01 June 2021

**RE: LLFA Response – 6/2020/3222/MAJ, Former Volkswagen Van Centre, Comet Way, Hatfield, AL10 9TF**

**RE: 6/2020/3222/MAJ – Former Volkswagen Van Centre, Comet Way, Hatfield, AL10 9TF**

Proposed Masterplan

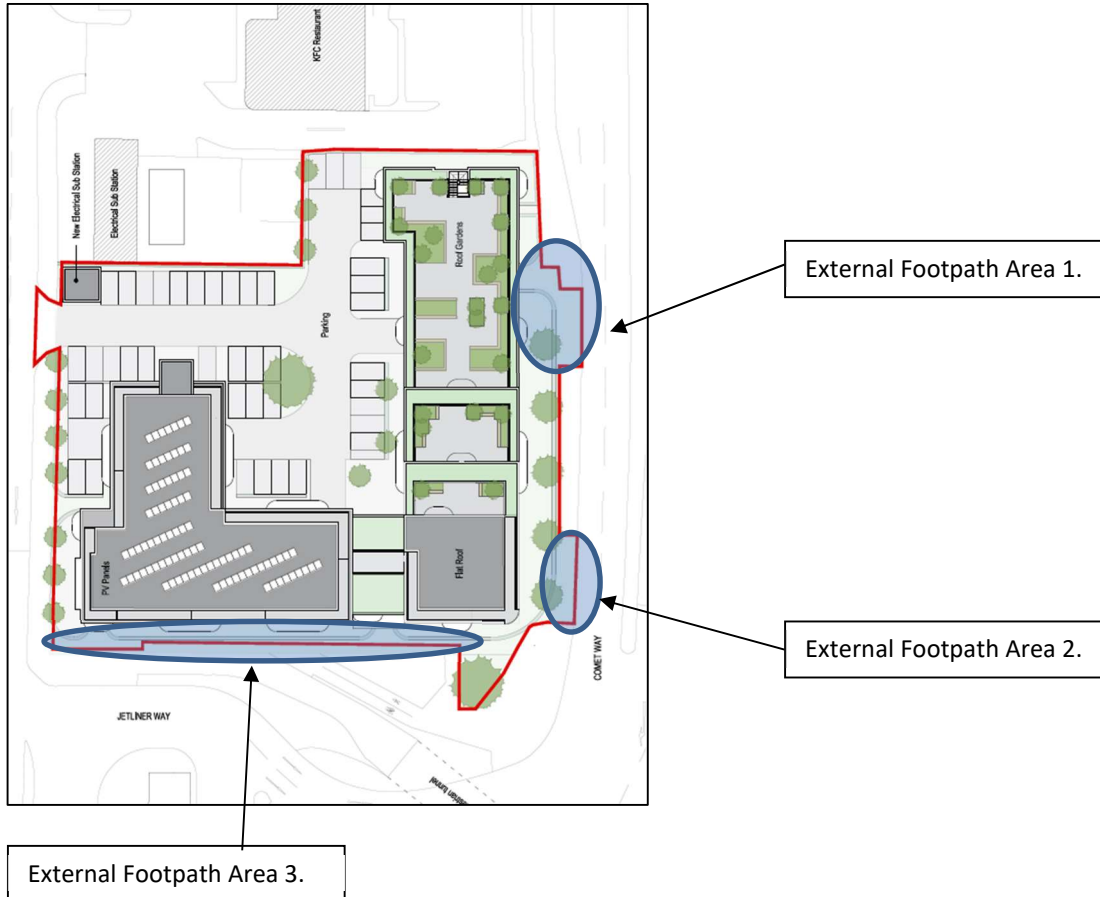
*“We note that some of car parking areas, located outside of the building footprint, will be provided with permeable paving with sub-base. However, there are some parking spaces where these structures cannot be provided. Therefore, the applicant should clarify how surface water from those areas will be captured and treated prior to reaching the piped network.*

*Moreover, it should be clarified and identify on a plan how the rest of undercroft parking will be drained, as no information has been provided.*

*As the LLFA, we are assessing surface water drainage within the application’s red line boundary. Therefore, the applicant should clarify how they intend to drain new proposed footpaths around the building.*

The car parking impermeable areas on the site will drain to the adjacent lined porous paving areas. Our drainage strategy drawing has been updated and attached to make this clearer. Our post development calculations had included these impermeable areas and showed this can operate as shown.

We acknowledge the undercroft parking drainage was not referenced in the drainage statement as this will form part of the internal building drainage and services design. However, we do acknowledge that some minimal rainwater egress may occur from the entrance of vehicles and in the winter, snow accumulation from cars also needs to be considered. The drainage for this area will likely discharge to the foul sewer. The development proposals were issued as part of the pre-application request to Thames Water and an assumption made on the potential overall rate applicable to the foul drainage for the site. No objection was raised by Thames Water; however, to ensure this will be captured at the detail design stage reference has been made to this on the updated drainage strategy drawing.

The external (outer edge of the proposed building) of existing and retained footpaths, have been referenced on the updated drainage strategy drawing. For clarification the existing and re-surfaced proposed areas are shown below along with the drainage proposed for each location.

Drawing Issue Status		
<b>FOR PLANNING</b>		
<b>COMET WAY, HATFIELD</b>		
<b>PROPOSED SURFACE WATER DRAINAGE</b>		
Client		
<b>COMET WAY HATFIELD LTD</b>		
Date of 1st Issue	Designed	Drawn
12.11.2020	EE	JS
A3 Scale	Checked	Approved
1:500	EE	-
Drawing Number	Revision	
<b>47179/4001/002</b>	<b>A</b>

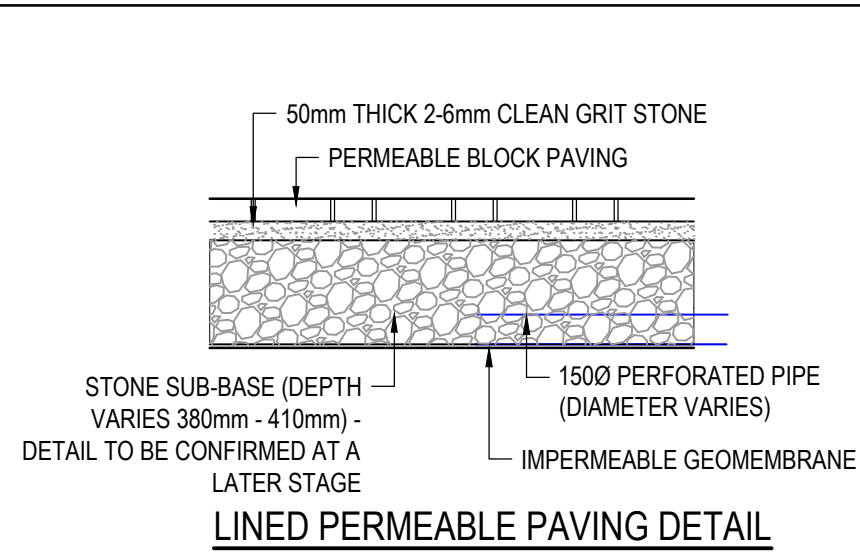
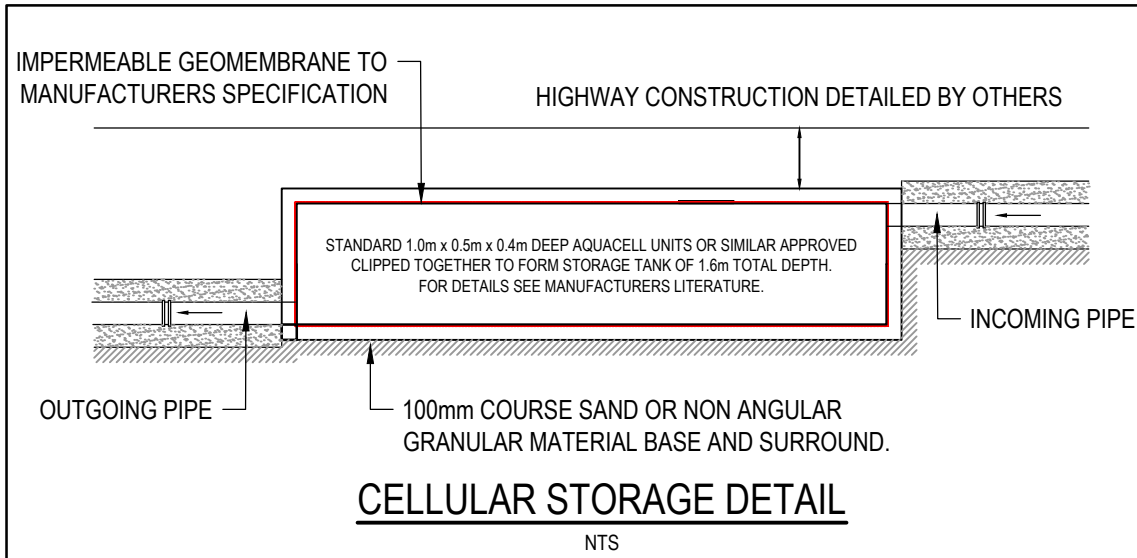
*On the submitted drainage plan the proposed depth of the cellular storage does not match with the cross section drawing included. We would advise this should be consistent and the layout plan should be updated. In addition, depth of permeable paving sub-base structure should be also clarified.*

There was an error in tank depth made on the drainage section shown on the surface water drainage strategy drawing, this should be 1.6m depth, this has been updated. Depth of porous paving sub-base from our calculations is also referenced on the updated drainage drawing.
